Gate Burton Energy Park Environmental Statement

Volume 3, Appendix 10-K: Lincolnshire County Council Consultation Meeting Notes
Document Reference: EN010131/APP/3.3
January 2023

Minutes

Meeting name	Subject	Attendees
Gate Burton Solar Farm	Review of additional viewpoints/photomontages suggested by Lincolnshire County Council	OB - Oliver Brown (on behalf of LCC) JS - Joerg Schulze (AECOM) RW - Rupert Wilson (AECOM)
Meeting date	Time	
30.03.2022	2.30pm	
Location	Prepared by	
MS TEAMS	Rupert Wilson, Joerg Schulze

Viewpoint 9: B1241

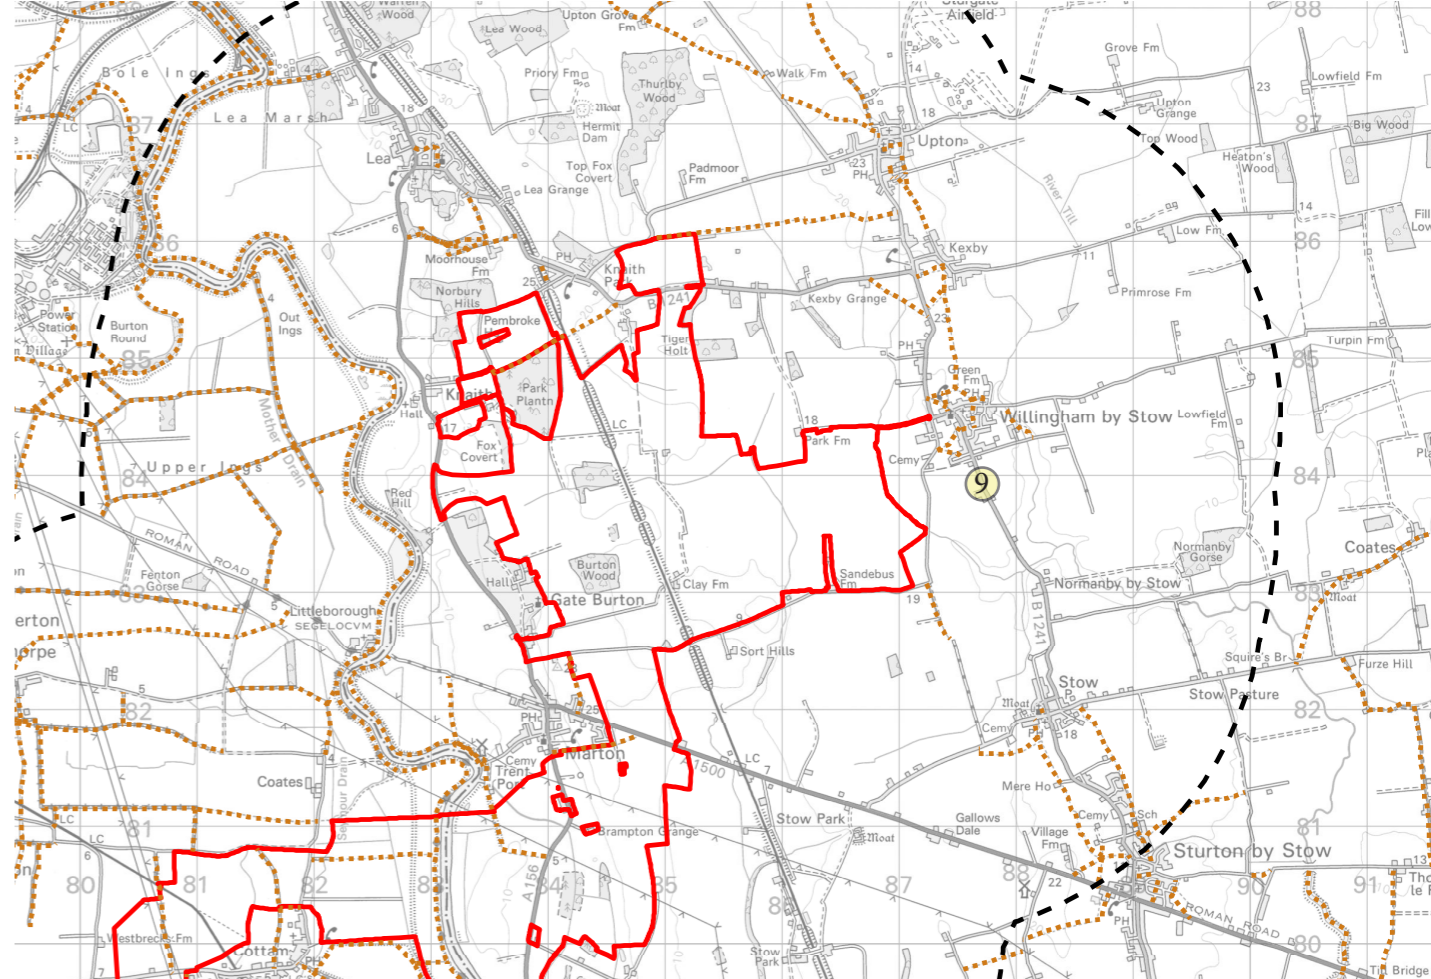
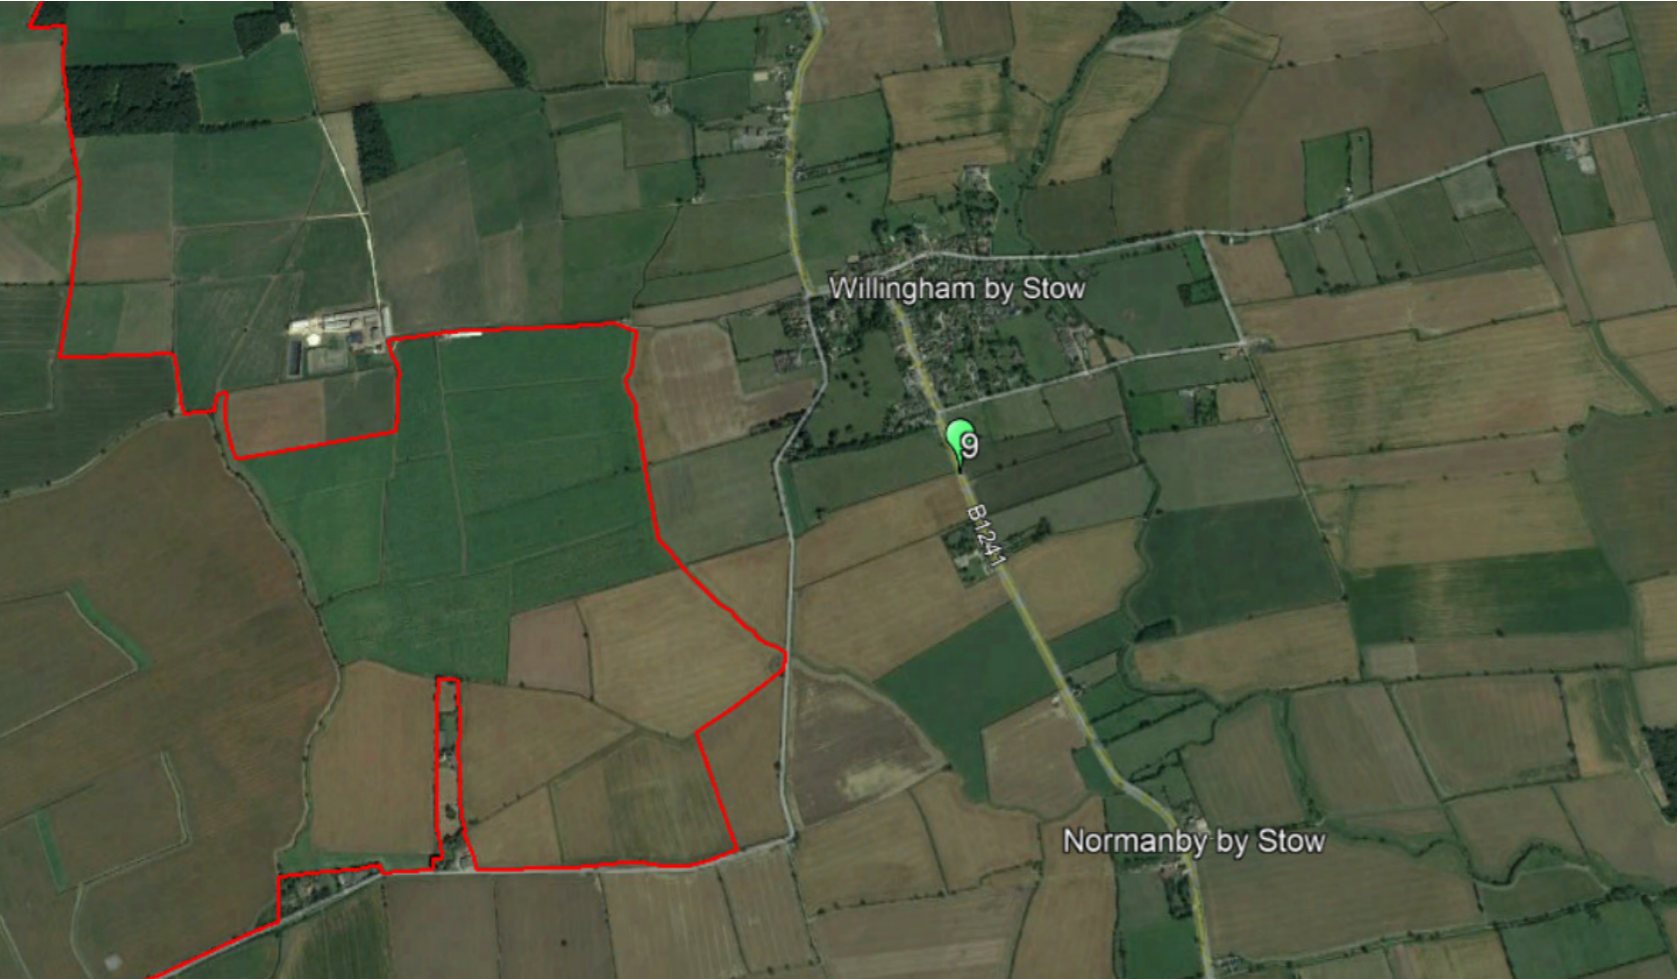
Viewpoint 9 will have a view of the upper elements of the solar park at this viewpoint. **Photomontage Suggested.**

- Viewpoint 8: Station Road - Viewpoint 8 will have a view of the solar park at this viewpoint. Photomontage Suggested. **AGREED**
- Viewpoint 9: B1241 - Viewpoint 9 will have a view of the upper elements of the solar park at this viewpoint. Photomontage Suggested. **AGREED**

Viewpoint 10: Moorhouse Farm PRow Public Footpath; Lea/1056/1

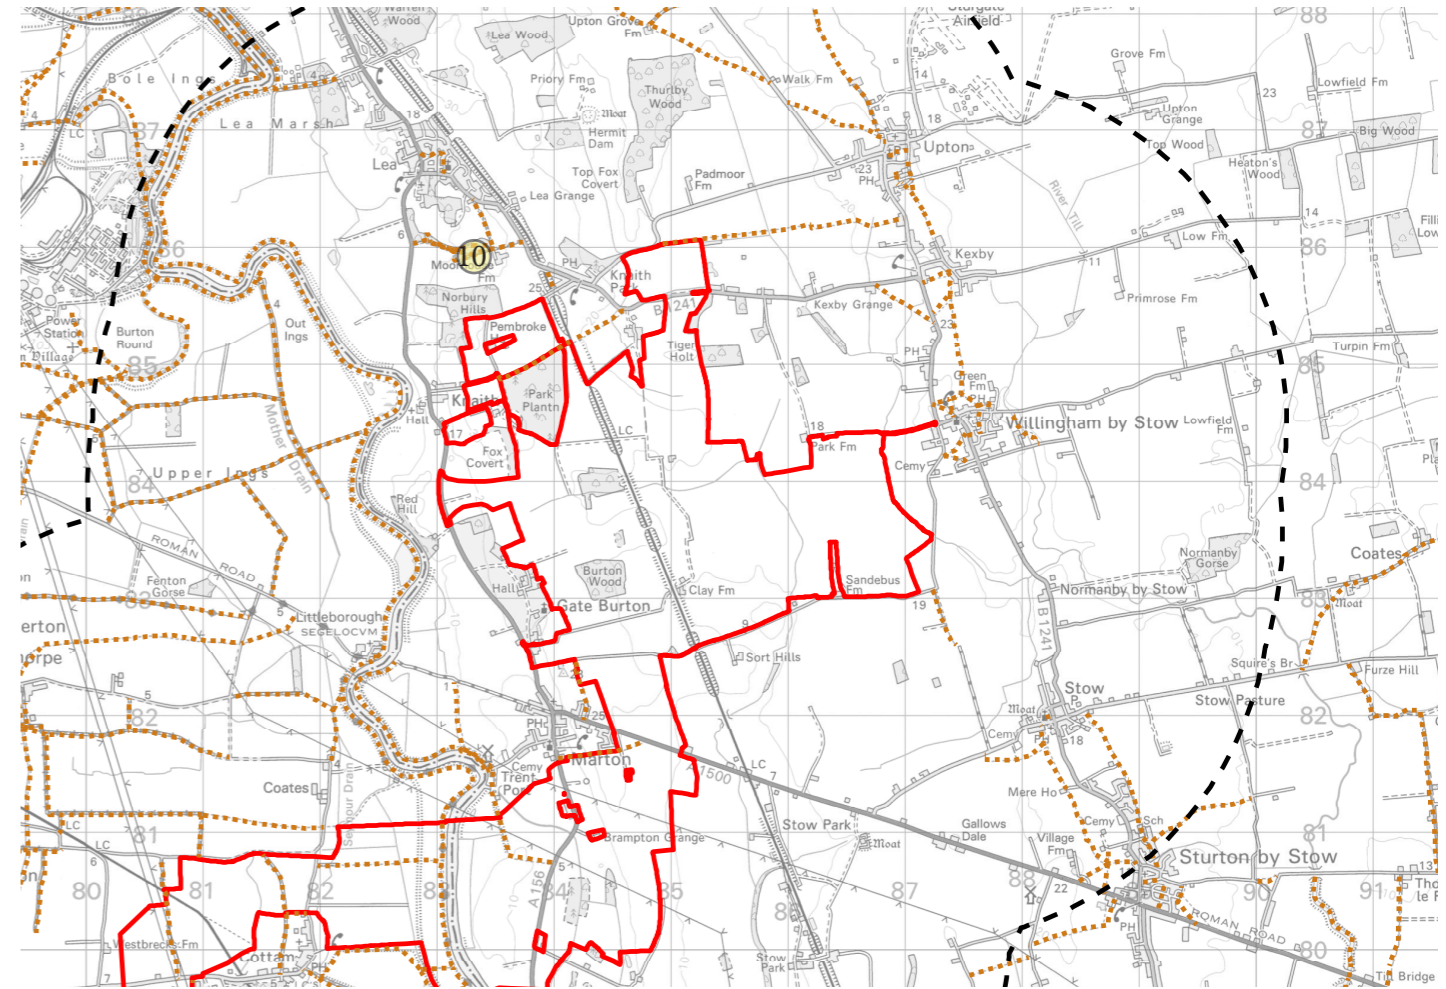
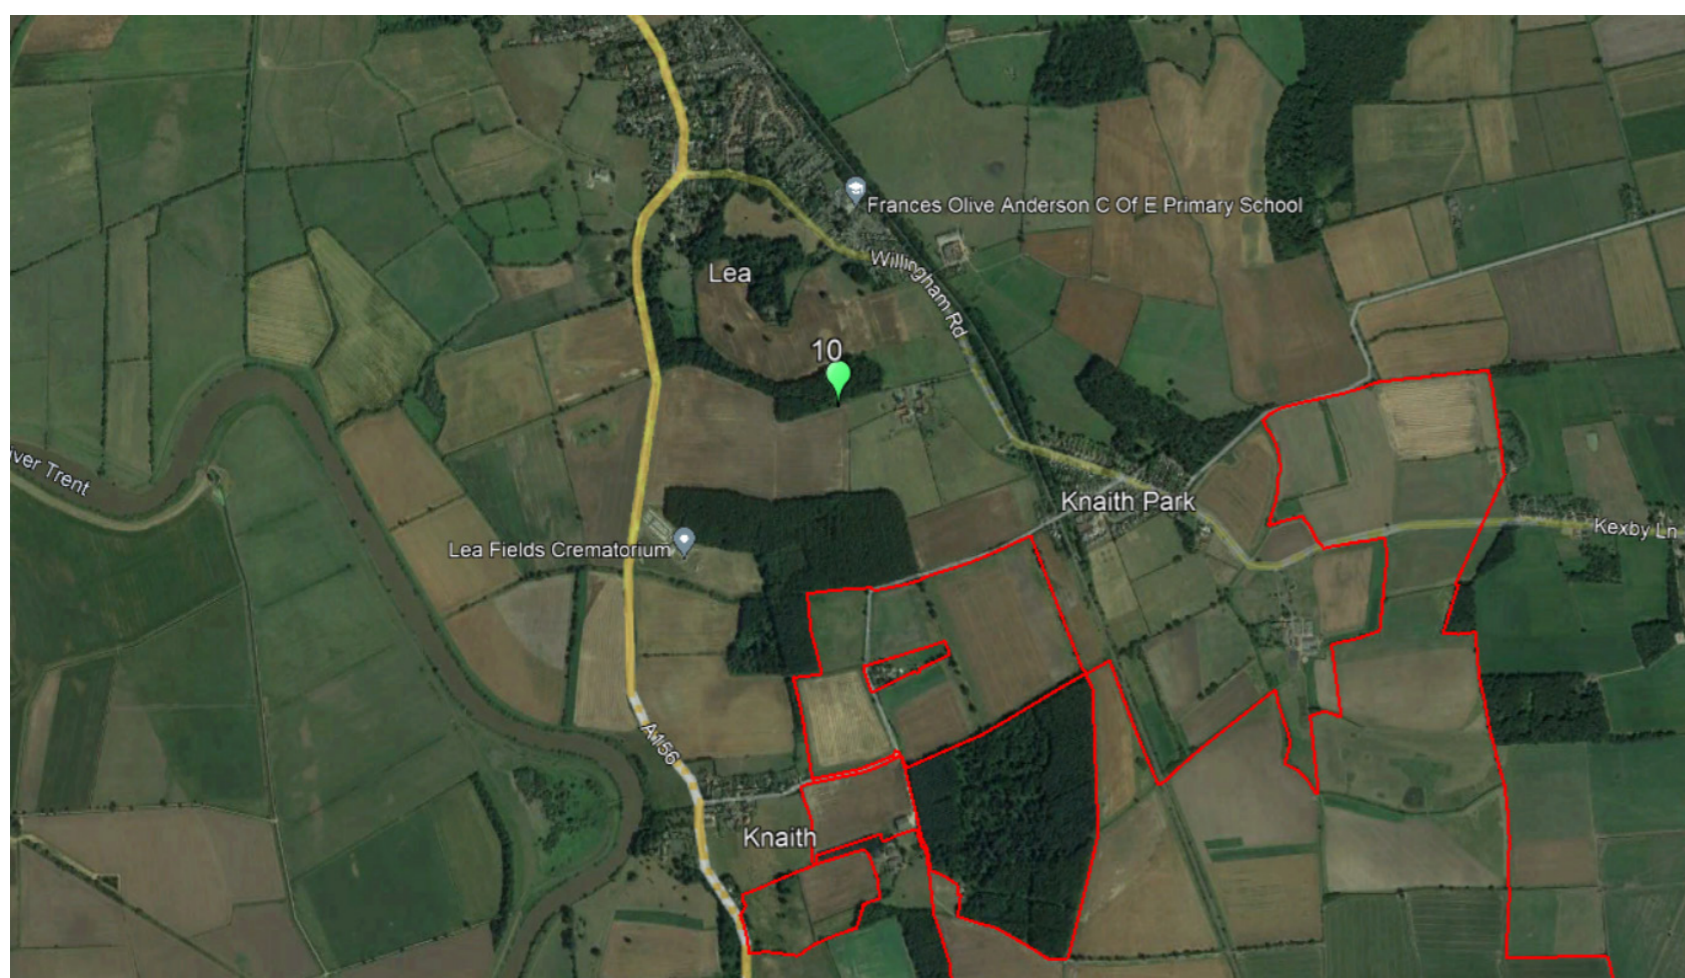
Viewpoint 10 will not have a view of the solar park at this location given the screening by vegetation seen in this view-point. **No Photomontage Suggested.**

- Viewpoint 10: Moorhouse Farm PRow Public Footpath; Lea/1056/1 - Viewpoint 10 will not have a view of the solar park at this location given the screening by vegetation seen in this viewpoint. No Photomontage is Suggested. **AGREED**

Viewpoint 11: B1241

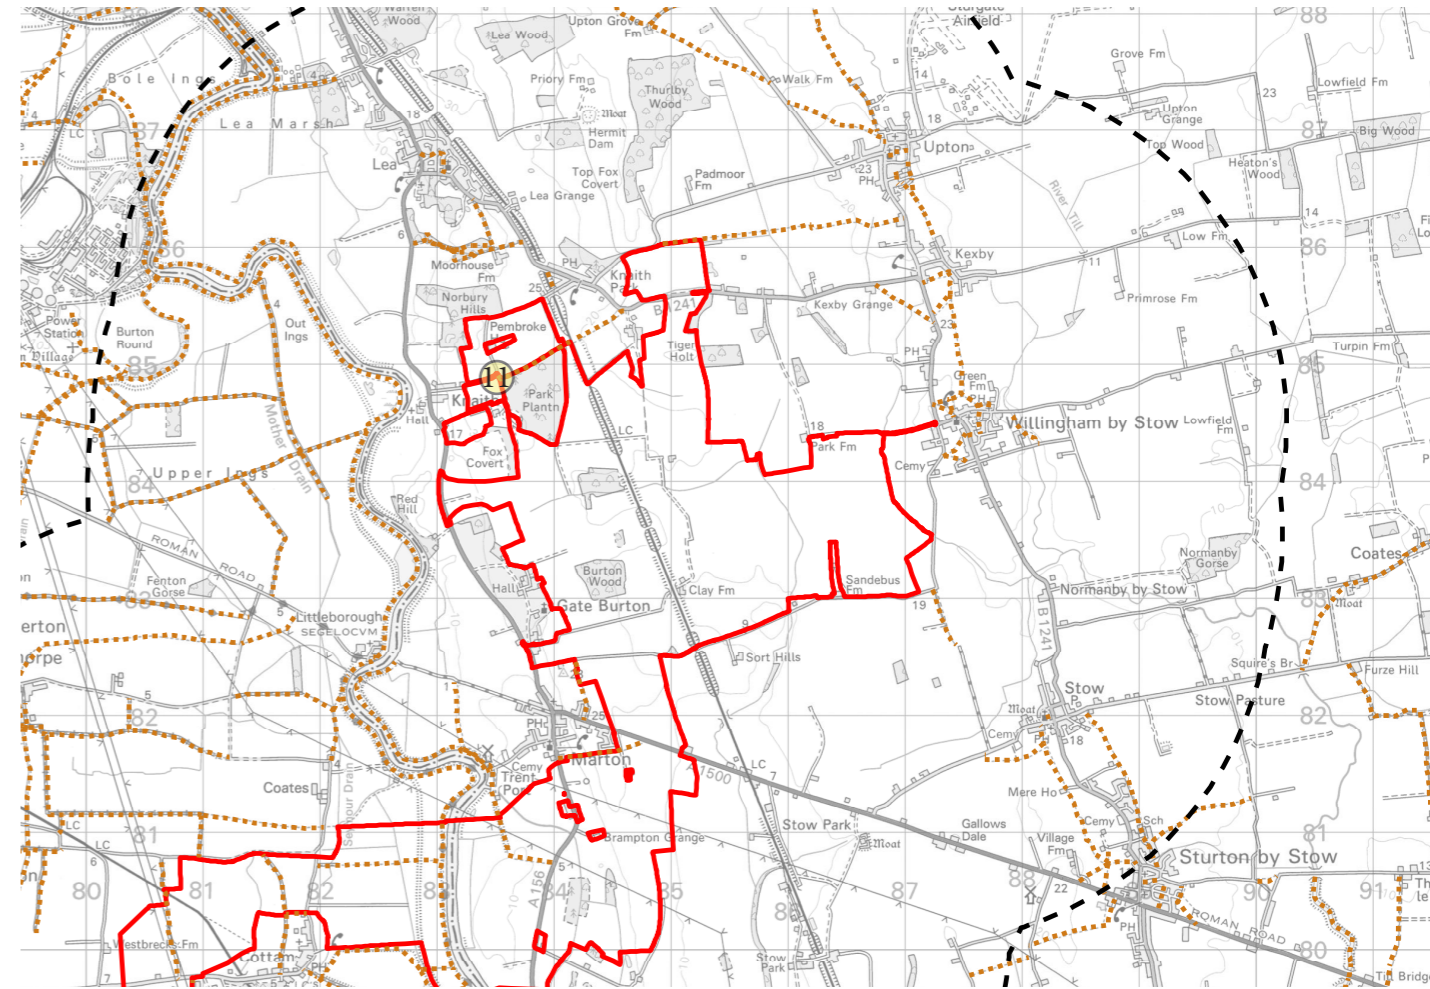
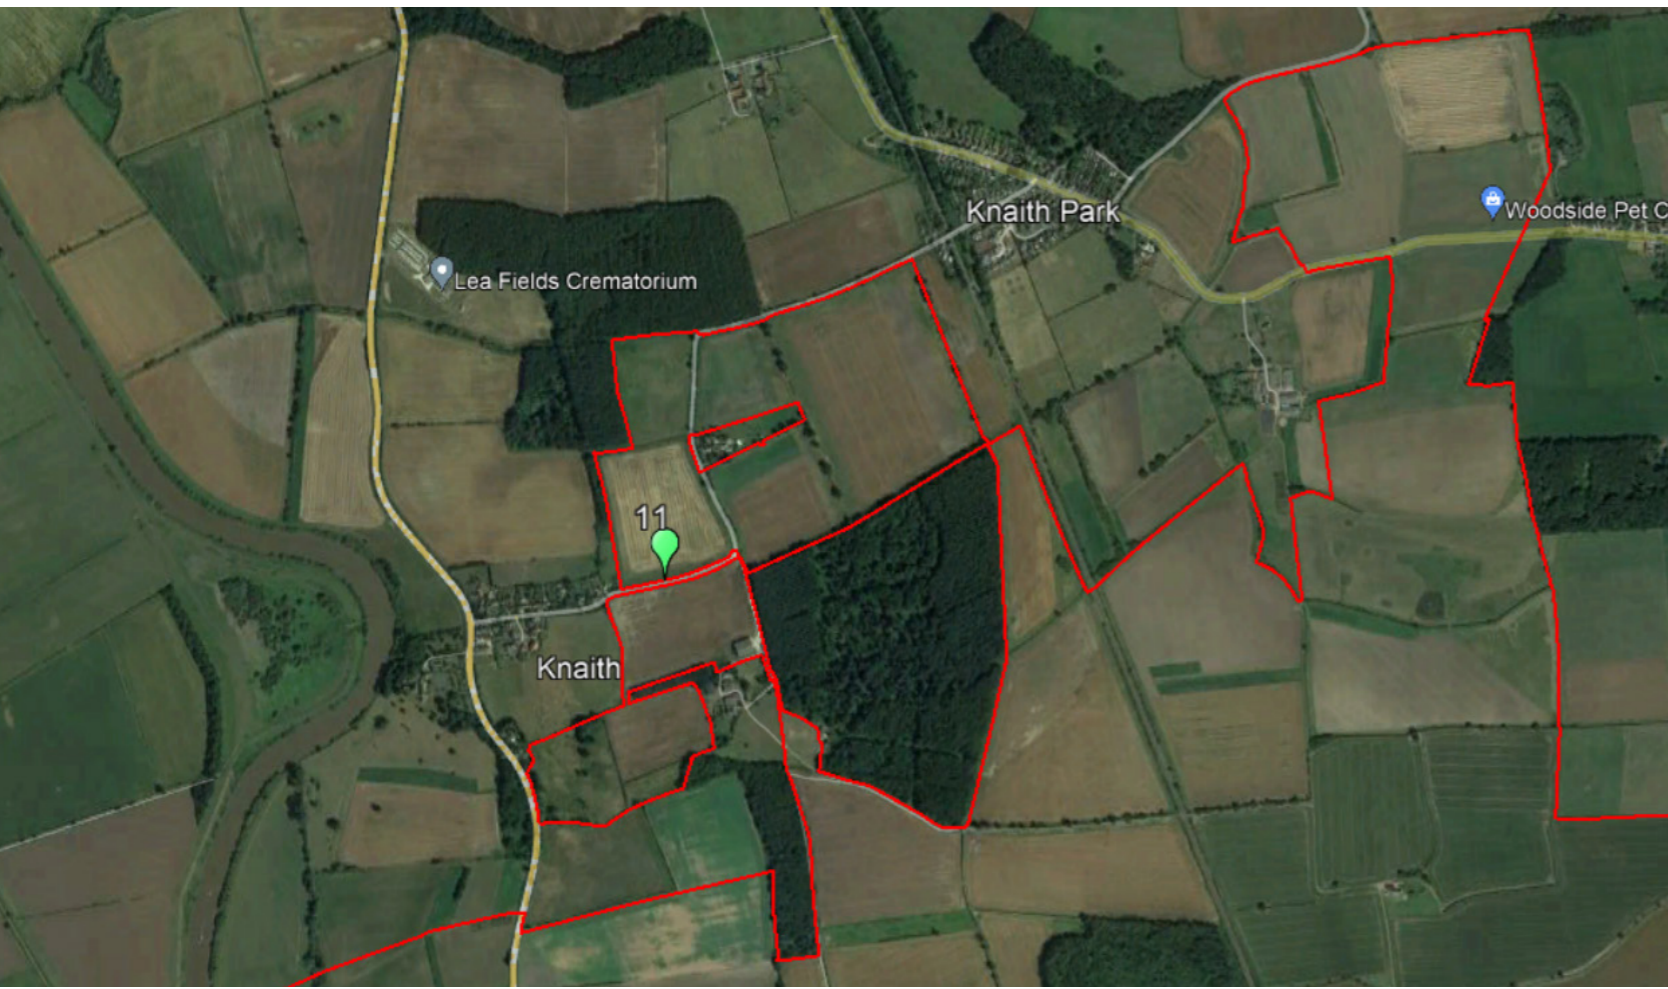
Viewpoint 11 will have a view of the upper elements of the solar park at this viewpoint. **Photomontage Suggested.**

- Viewpoint 11: B1241 - Viewpoint 11 will have a view of the upper elements of the solar park at this viewpoint. Photomontage Suggested. **AGREED**
- Viewpoint 12: Park Plantation PRow Public Footpath; Knai/44/2 - Viewpoint 12 will have a view of the solar farm at this location. No site photography was captured. Photomontage Suggested. **AGREED NOT TO DO A PHOTOMONTAGE DUE TO SAFETY/ACCESSIBILITY ISSUES.**
